# Final Reclamation Inspection

Operator: HIGHPOINT OPERATING CORPORATION- 10071

Location ID: 323189

Inspection Photos  
Location Name: LOVELY-66N66W /9SESW  
Location ID: 323189

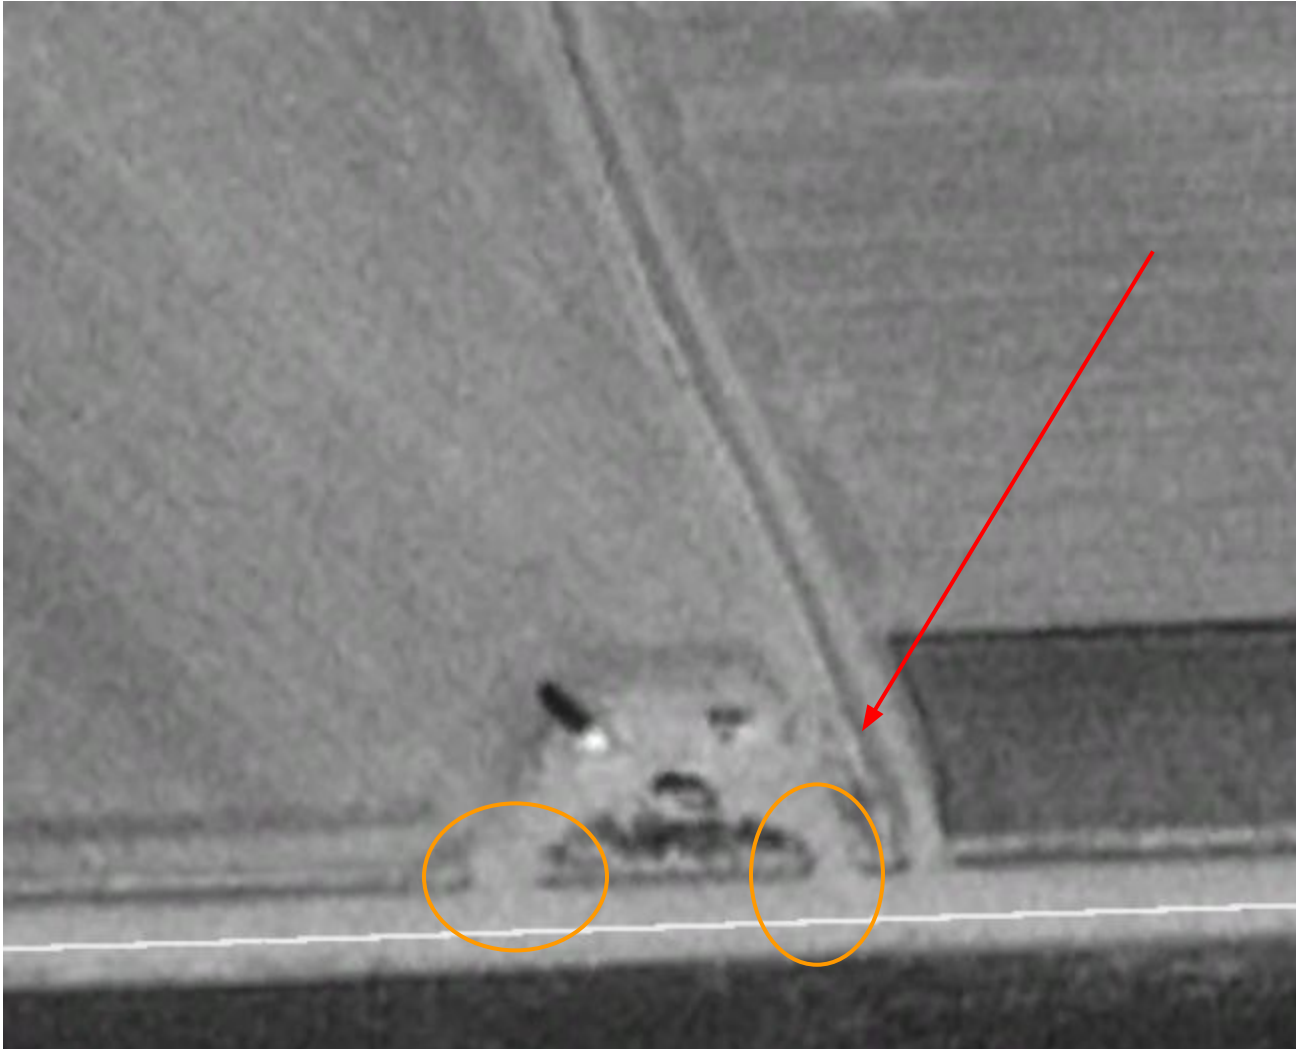
**Photo 1.** Google Earth aerial imagery taken 10/3/1999. Imagery is illustrating that the original access was limited to two entry points off CR 70 (orange circles). Red arrow illustrates a bar ditch along a two-track.

**Photo 2.** Google Earth aerial imagery taken 10/7/2004. Imagery is illustrating that an additional access (red arrow) was installed along the eastern perimeter of the location; therefore, a culvert (red circle) was installed and a section of the bar ditch along the eastern perimeter of the location was removed. As of 10/7/2019, Operator has failed to remove the culvert (orange circle) and put the bar ditch back in.

**Photo 3.** Photo taken of the culvert from the tank battery location that was illustrated in the previous aerial imagery.

**Photo 4.** Photo taken from the eastern tank battery location, facing North. Photo illustrates the Operator has failed to remove the culvert and put the bar ditch back in. Bar ditch plays an important role as this area is flooding irrigated.

**Photo 5.** Photo taken from the southwestern tank battery location, facing Northeast. Photo illustrates the Operator failed to properly contour the location to match the surrounding landscape to allow for successful flood irrigation. There appears to be a perimeter ditch along the outside and the location itself is elevated compared to the surrounding landscape. Location is to the right of the red-dashed line.
